# 802.3df D1.0

# Comment Resolution

## P802.3df editorial team

Figure 116-2—200GBASE-R inter-sublayer service interfaces

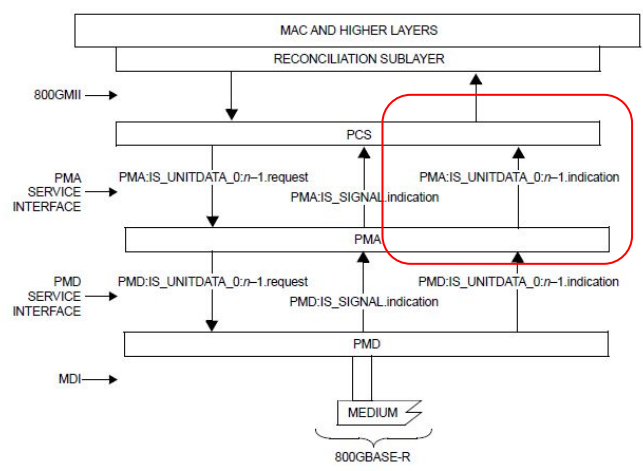
In Figure 116-2, multiple lanes are shown explicitly: PMA:IS\_UNITDATA\_0.request  
 PMA:IS\_UNITDATA\_1.request ... PMA:IS\_UNITDATA\_7.request

**Suggested Remedy**  
 As a compromise, follow e.g. Figure 120G-2; add the short diagonal lines "n" to show n lanes, not n requests on one lane with a constant ordering. Several figures, including Fig 172-2 where showing the numbers, 16 and 32, will be helpful.

**Proposed Response** Response Status W  
**PROPOSED REJECT.**  
 A single line with an SI parameter with vector notation clearly conveys the fact that there are multiple lanes 0 to n-1. This approach is used to reduce the clutter compared to similar diagrams in Clause 116. This approach is used consistently in various figures in 802.3df. The proposed changes do not improve the accuracy or clarity of the draft.

The interfaces as shown in Clause 116 were overly cluttered and difficult to read.

Replace Figure 120G-3 with the following:

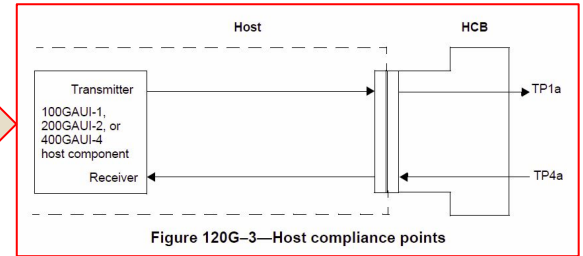
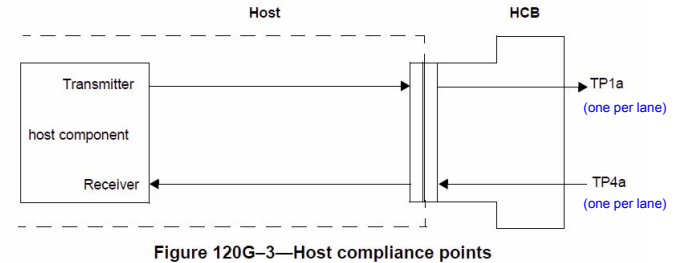
As dealing with larger numbers of lanes in compliance boards is an engineering issue...  
 And by the way, it might have been helpful to show that these are differential.

It would help to add the short diagonal lines showing n lanes. Also Figure 120G-4

PROPOSED ACCEPT IN PRINCIPLE.  
 The test points are separate for each lane.  
 However, the clarity of the figure may be improved.

Add the label "(one per lane)" below TP1a and TP4a in Figure 120G-3, and below TP1 and TP4 in Figure 120G-4.  
 In the second and third paragraphs of 120G.2, change "the location of compliance points" to "the location of compliance points for each lane".

Figure 172–2—Functional block diagram

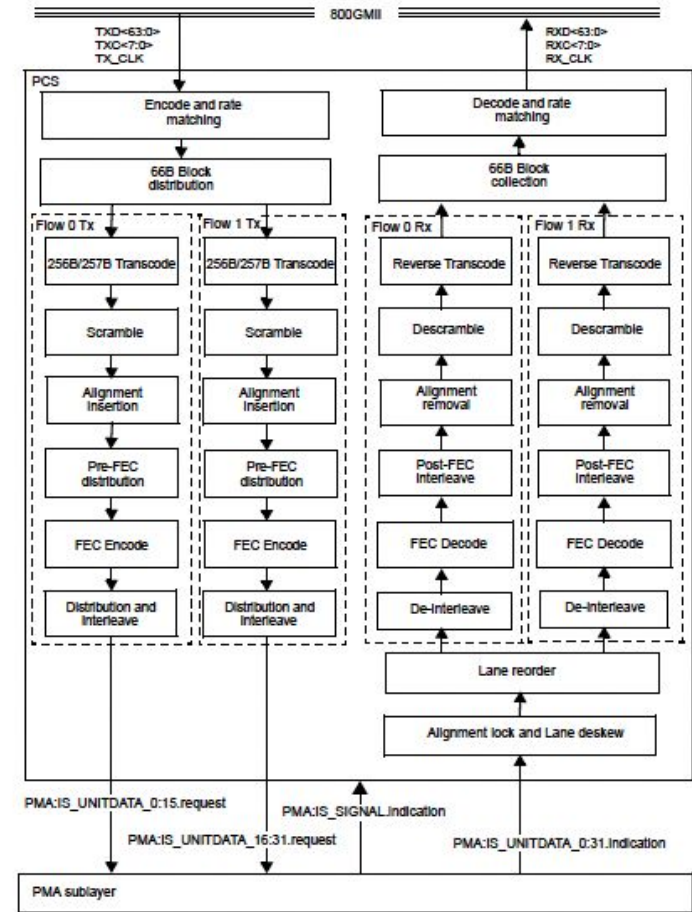
Figure 172-2—Functional block diagram  
The block diagram includes two flows for TX and Rx.  
Both TX flows are supposed to insert the alignment markers in sync with each other. This does not appear explicitly in the diagram.

The baseline (shrikhande\_3df\_01a\_221004, see slide 10) shows that the two flows' alignment insertion are connected. 172.2.1 ignores this too, although 172.2.4.4 says what to do, but it should be made obvious in the figure that a linkage is needed.

D1.0 uses the highlighted text in 172.2.4.4 to specify the AM insertion requirement shown in slide 13 of the baseline, without defining a specific implementation.

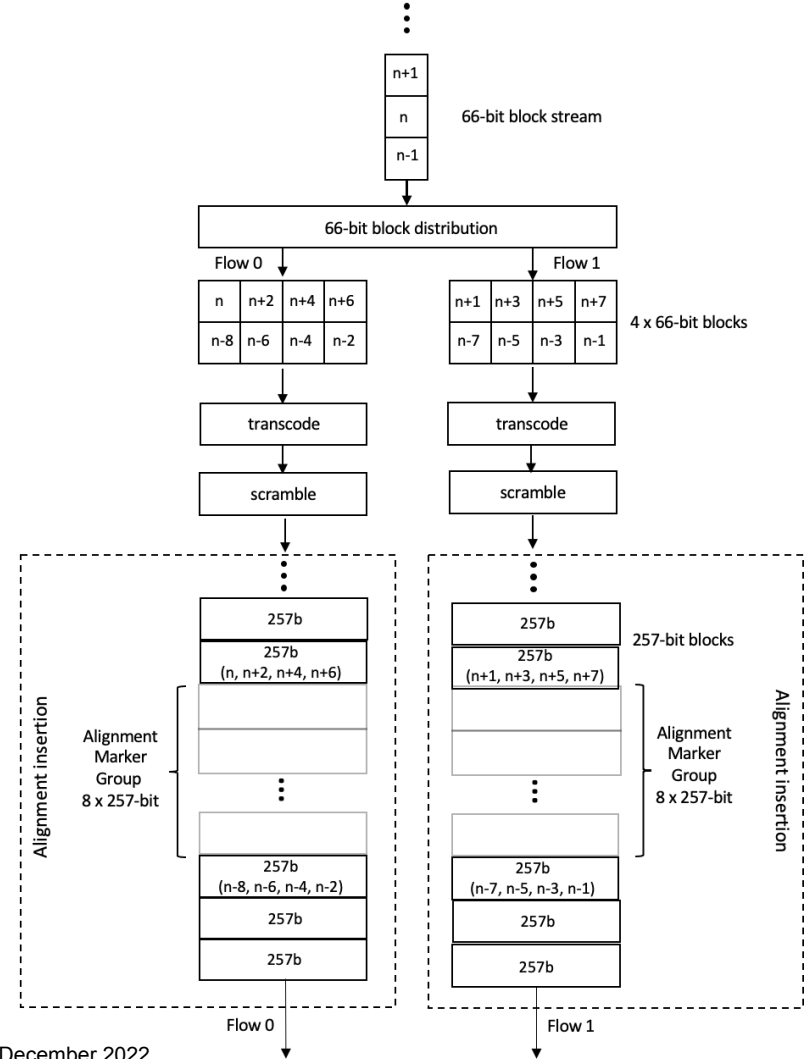
Missing the relationship of the flow 0 257-bit block to the AM group

Include the following diagram in 172.2.4.4, with editorial license.

“The alignment marker insertion within each flow shall occur at the same point relative to the original stream of 66-bit blocks before block distribution. This requirement is illustrated in Figure 172-x where the alignment marker group is inserted prior to the 257-bit block containing the 66-bit block “n” for flow 0 and prior to the 257-bit block containing the 66-bit block “n+1” for flow 1.”

Figure 173-3—32:8 PMA Functional Block Diagram

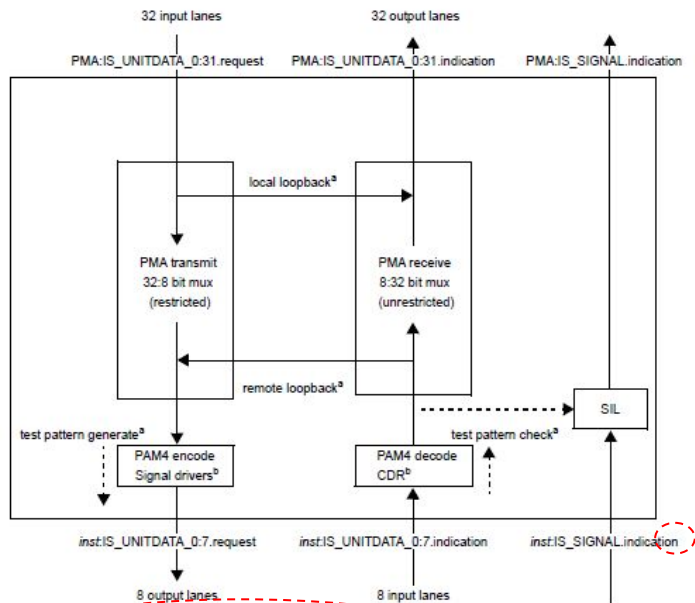
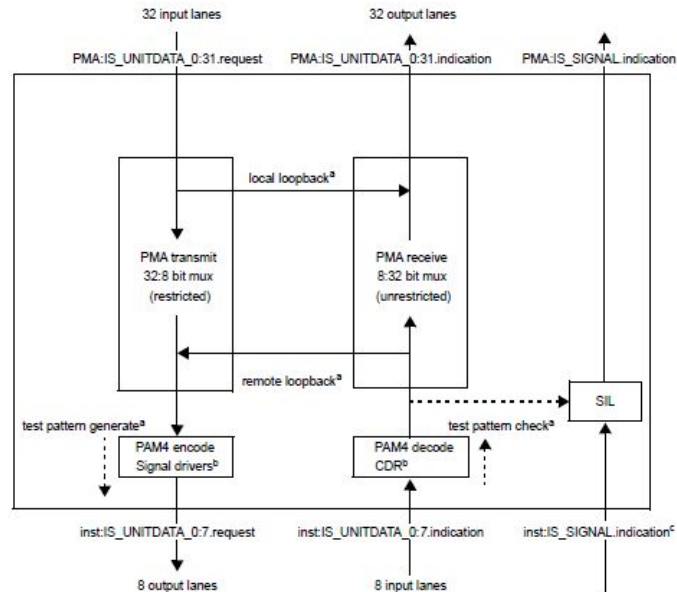
Figure 173-4 (8:32 PMA) there should be no PMA:IS\_SIGNAL.indication towards the PMA (AUI is not able to transfer an out of band status signal) and possibly no "SIL" block in the block diagram.

Figure 173-3/4/5/. Need to make it clear if the sublayer above or below is another PMA , that the interface is connected over a physically instantiated AUI (800GAUI-8)

For the 32:8 and 8:8 PMAs the *inst*:IS\_UNITDATA\_0 primitives are defined for  $i = 0$  to 7. Note that electrical and timing specifications of the service interface are defined if the interface is physically instantiated (e.g., 800GAUI-8), otherwise the service interface is specified only abstractly. The interface between the PMA and the sublayer below consists of 8 lanes for data transfer and a status indicating a good signal from the sublayer below the PMA (see Figure 173-3 and Figure 173-4).

Replace with the following:

- ❖ Update Figures 173-3/4/5 with the corresponding figures shown on previous slides, and update any associated text accordingly.
- ❖ Update Clause 171 according to previous slides, add DTE 800GXS and PHY 800GXS service interface definitions, and update any associated text accordingly.
- ❖ Update Figure 169-3 based on the figure shown in previous slide and update any associated text accordingly.

Figure 173-4—8:32 PMA Functional Block Diagram

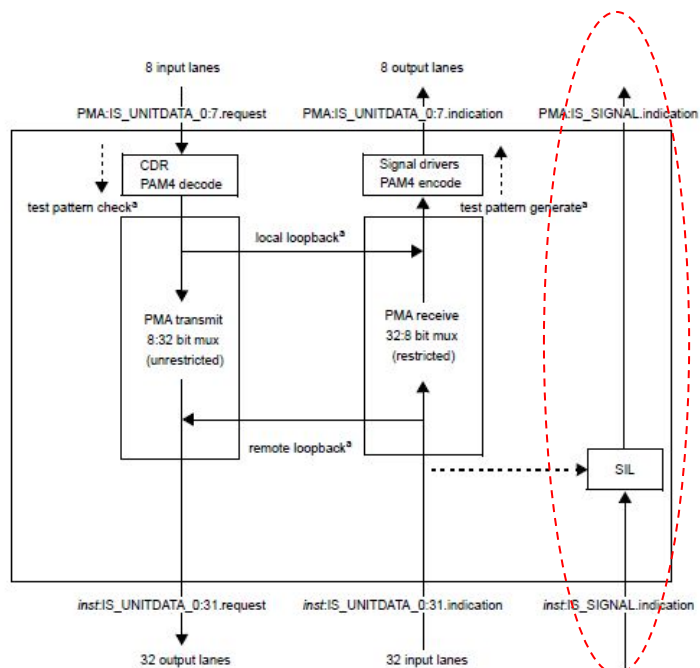
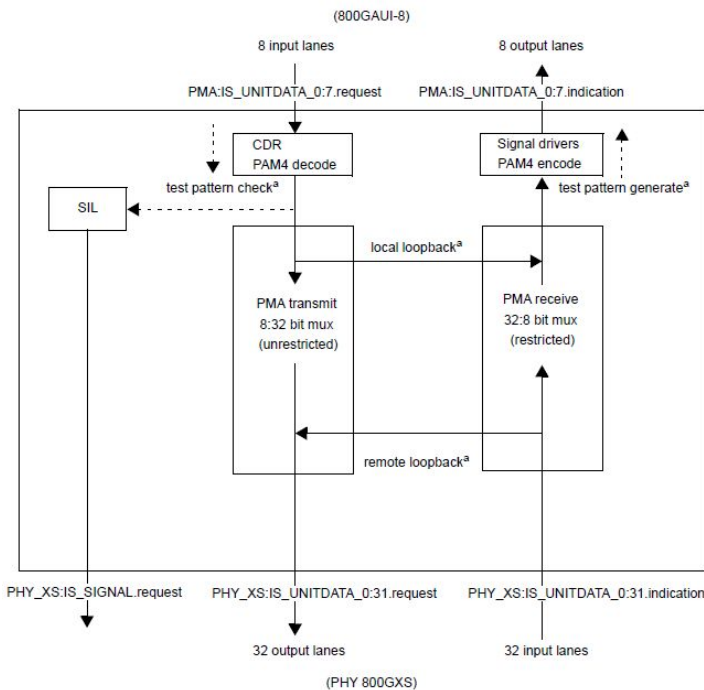
"In the case where the sublayer below the PMA is a PHY 800GXS the PMA does not receive a PHY\_XS:IS\_SIGNAL.indication as an input to the SIL". Figure 173-4 that describes this interface does include the PHY\_XS:IS\_SIGNAL.indication

Replace with the following:

Figure 173-5—8:8 PMA Functional Block Diagram

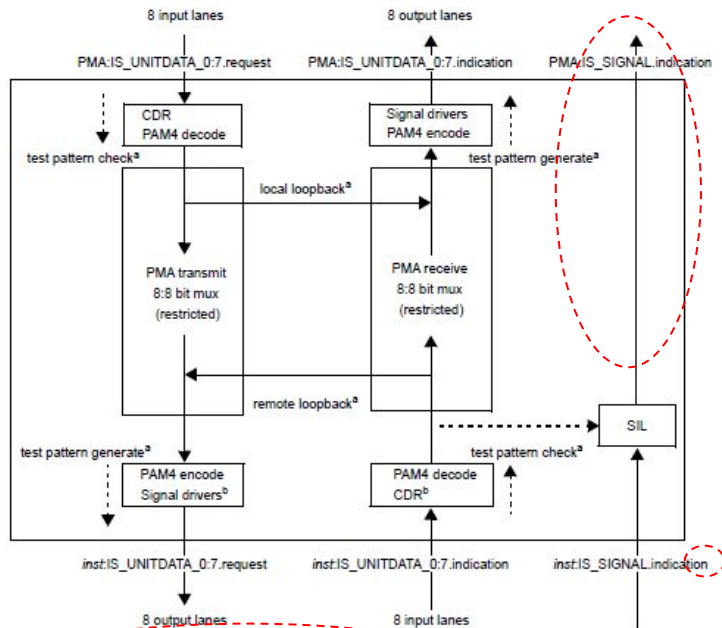
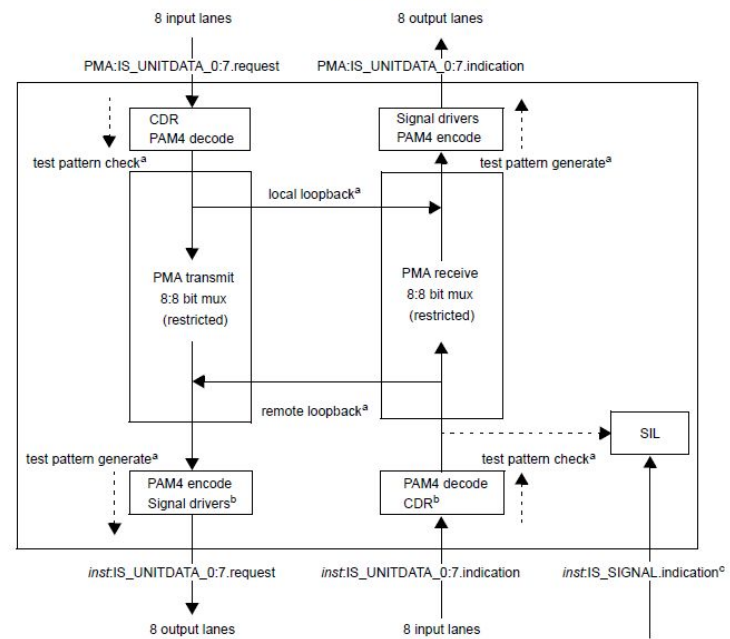
The same comment applies to the 8:8 PMA in Figure 173-5.

Replace with the following:  
 (800GAUI-8)

Figure 169-3—800GBASE-R inter-sublayer service interfaces including 800GMII Extender

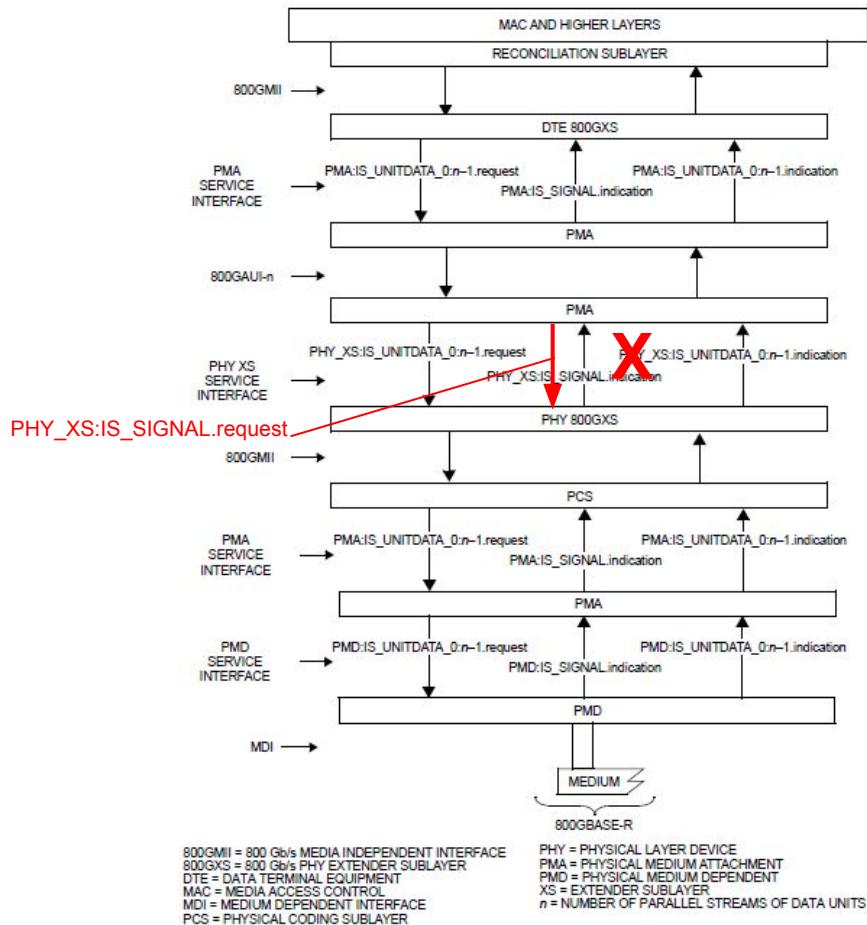
- ❖ The PHY 800GXS functionality and service interface is not explicitly defined in Clause 171.
- ❖ The functional block diagram for the PHY 800GXS is shown on this slide.
- ❖ The PHY 800GXS is essentially an upside down 800GBASE-R PCS, and as a result the service interface is somewhat different to the 800GBASE-R PCS service interface that is defined in Clause 172 (for example the service interface receives an IS\_SIGNAL.request signal and rather than an IS\_SIGNAL.indication signal)
- ❖ Clause 171 should be updated to show the PHY 800GXS functional block diagram and to define the PHY 800GXS service interface.

❖ Update Figure 169-3 as shown.
